**REQUEST**

Current Zoning: R-3 LWPA (single family residential)  
Proposed Zoning: MX-2 LWPA (mixed use development)

Approximately 43.58 acres located on the southwest side of Belmeade Drive, northwest of Rhyne Rd.

**SUMMARY OF PETITION**

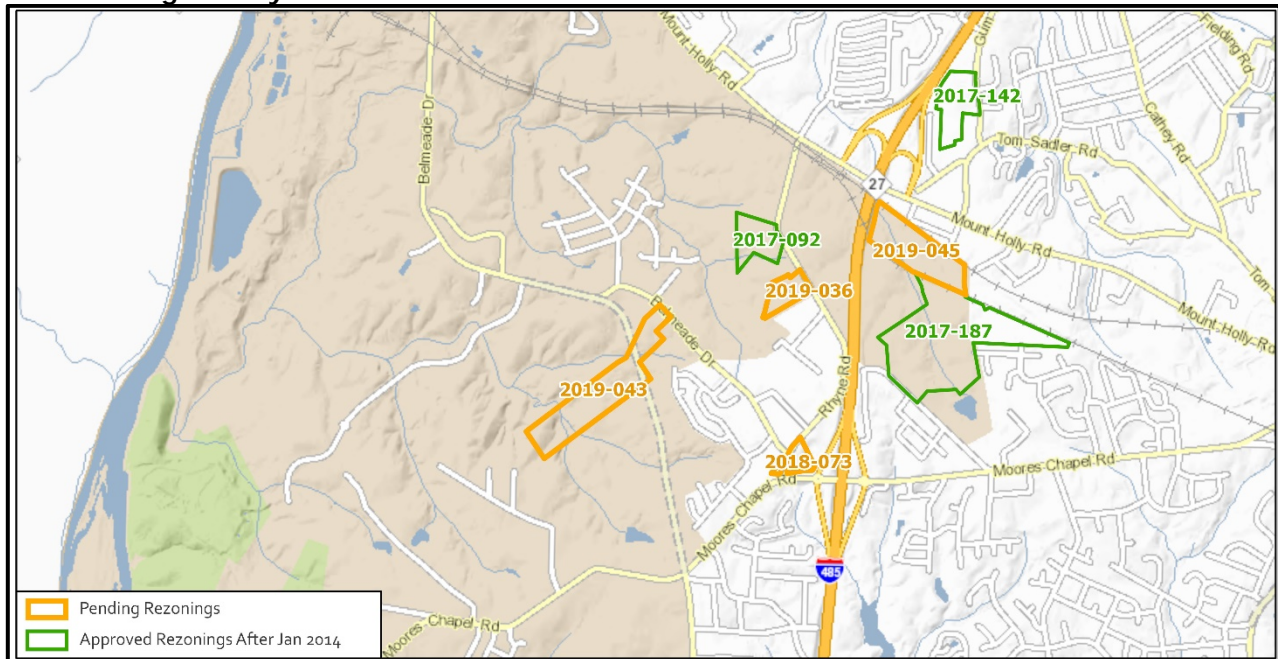
1. Commit to construct the curb and gutter along Belmeade Drive as per required under Chapter 19. The site plan should locate and dimension the curb and gutter from the road centerline. The location of the future back of curb on Belmeade Drive is 25 feet as measured from the Belmeade's existing centerline. The location of the curb and gutter includes space for bicycle facility.
2. Revise the site plan to add a note specifying all transportation improvements will be approved and constructed before the site's first building certificate of occupancy is issued. The petitioner may phase transportation improvements if said improvements and phasing are explicitly described in site plan notes.
3. Revise the site plan and transportation conditional 3.k to provide 80 feet of total right-of-way through the site. A minor thoroughfare requires 80 feet total right-of-way outside Route 4.

4. Modify Architectural Standards Note 4.h. to specify minimum thickness of proposed vinyl siding on an attached dwelling will be .042 inches.
5. Label 37.5 Class C buffer (reduced with berm/fence) on the site plan.

6. Remove the "APPROXIMATE 40' SWIM BUFFER" label from the rezoning site plan (there is no such buffer).
7. Please remove the reference to the *Approximate 40-foot SWIM Buffer*. Buffers through this portion of the site are shown with the *35-ft PCSO Buffer and 100-ft LWPA Watershed Buffer*.
